APPLICATION NO.	FILING DATE	FIRST NAMED INVENTOR	ATTORNEY DOCKET NO.	CONFIRMATION NO.
10/807,583	03/18/2004	George E. Spooner JR.	84,040	4137

<b>Office Action Summary</b>	<b>Application No.</b>	<b>Applicant(s)</b>	
	10/807,583	SPOONER, GEORGE E.	
	<b>Examiner</b>	<b>Art Unit</b>	
	Michelle (Shelley) Clement	3641

## **DETAILED ACTION**

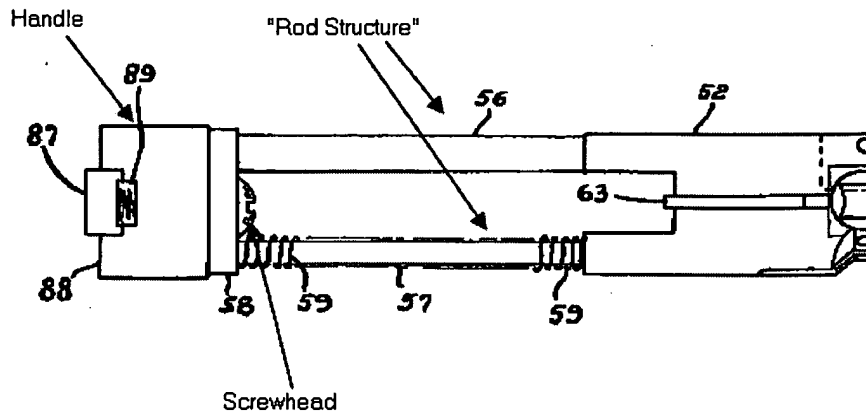
4. Claims 5-16 are rejected under 35 U.S.C. 102(b) as being anticipated by Jurek (US Patent # 4,069,607). Jurek discloses a bolt head (reference 52) (i.e. tool head) comprising: an arcuate peripheral surface of the head comprising a shape conforming to a segment of a cylinder with said cylinder having a predetermined axis running a length of the cylinder; a planar peripheral surface subtending the arcuate peripheral surface, the planar peripheral surface extends perpendicular to the arcuate peripheral surface and is disposed oppositely from a center of an arc which conforms to the arcuate peripheral surface; a forward axial end face terminating the arcuate peripheral surface and the planar peripheral surface, the forward axial end face includes at least one planar face surface which extends normal to the predetermined axis and a rectangular recess (the recess in which firing pin 63 resides)<sup>3</sup> being defined by the tool head and axially extending into the tool head in a first direction along the predetermined axis from the forward axial end face, wherein the rectangular recess radially extends openly inward from the arcuate peripheral surface into the tool head in a second direction perpendicular to the predetermined

axis, the rectangular recess radially extends completely through the arcuate peripheral surface so that the rectangular recess is oriented opposite the planar peripheral surface. The forward axial end face comprises an arcuate outer planar face surface, which extends radially inward from the arcuate peripheral surface, and a central planar face surface (reference 71) disposed radially within the arcuate outer planar face surface and recessed inwardly of the head from the arcuate outer planar face surface in a direction along the predetermined axis and wherein the central planar face surface is substantially perpendicular to the arcuate outer planar face surface. Further comprising a rod structure disposed at an end of the tool head oppositely of the forward axial end face that has the ability to attach a handle. The head is a single piece of unitary construction. The predetermined axis is perpendicular to the planar peripheral surface. The rectangular recess is a slot shaped configuration comprising a width oriented transverse to the predetermined axis. The tool head comprising a screwhead releasably attaching a handle.
